**TOWN OF NEWBURGH
PLANNING BOARD
TECHNICAL REVIEW COMMENTS**

PROJECT NAME: CBPS REALTY INC.
PROJECT NO.: 2021-13
PROJECT LOCATION: SECTION 34, BLOCK 2, LOT 29.1
REVIEW DATE: 14 JANUARY 2022
MEETING DATE: 20 JANUARY 2022
PROJECT REPRESENTATIVE: LANC & TULLY ENGINEERING

**SITE PLAN
PREPARED FOR**

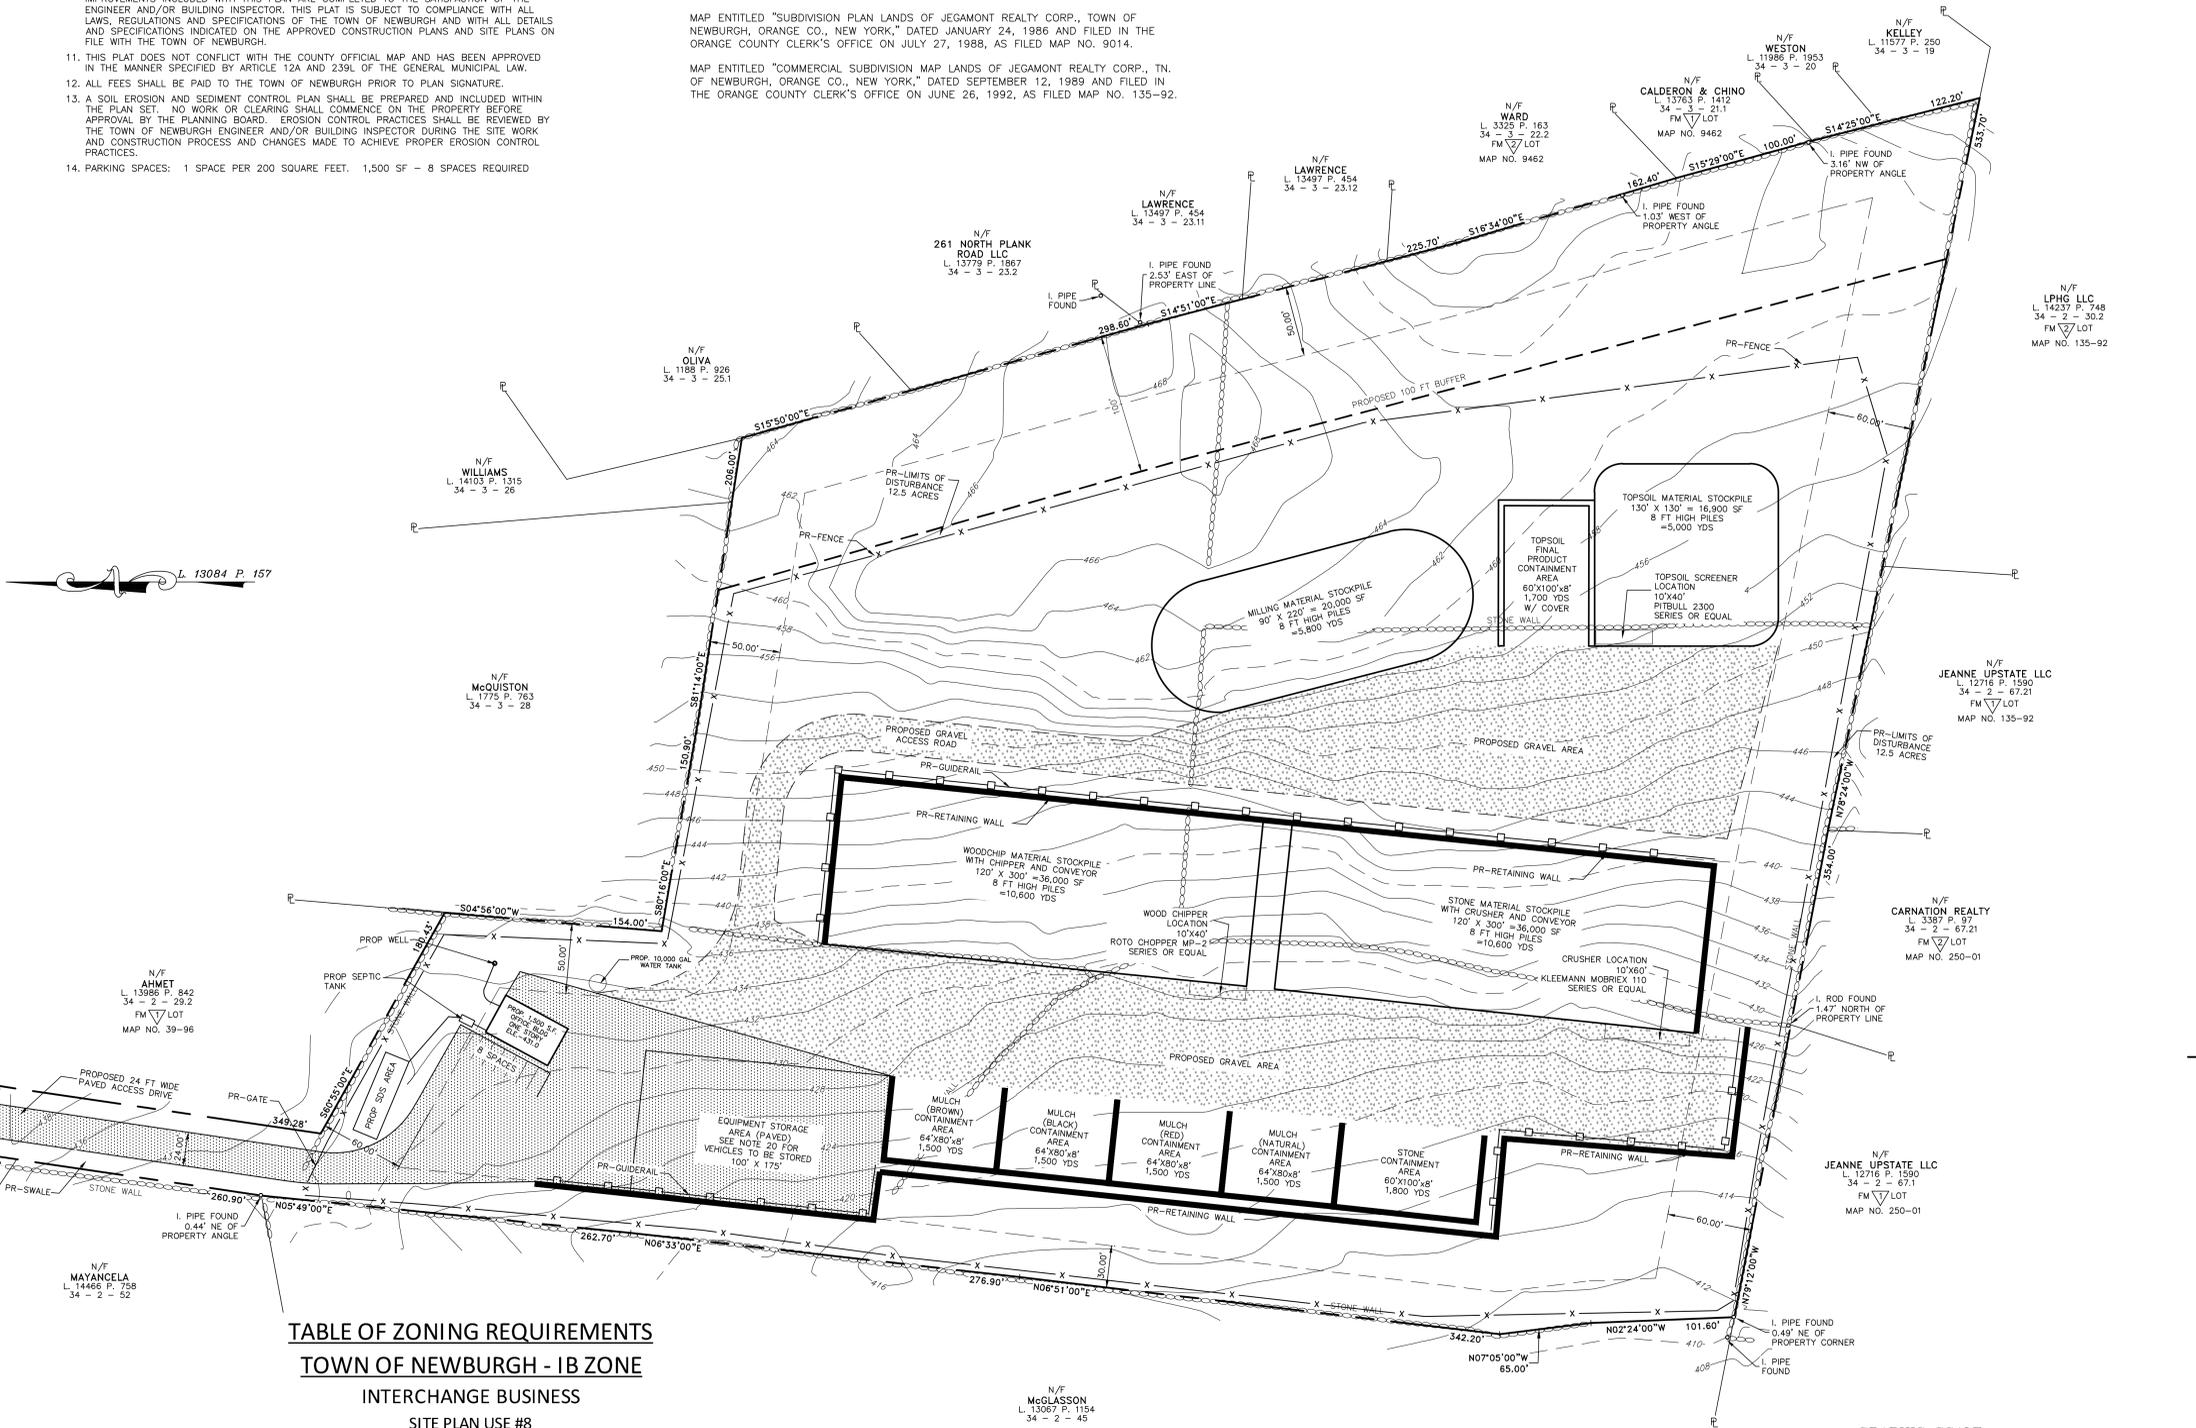
1. A detailed plan has been submitted identifying items which were discussed during a Technical Work Session. The full build out of the project has been depicted on the plans. Extensive retaining walls are proposed on the site. Top and bottom wall elevations should be specified on future submissions. Materials for the retaining walls should be identified.

2. One hundred foot buffer has been proposed along the east property line.
3. NYSDOT approval for the site access drive will be required.
4. Orange County Planning submission will be required upon submission of detailed plans.

9. The design of the subsurface sanitary sewer disposal system must be provided.
10. Two Types of retaining wall are depicted on the plans. Type of retaining wall should be depicted on the plan sheets in all locations.

11. It is noted a fence appears on the Site Plan. Details of the fence should be included on the plans.
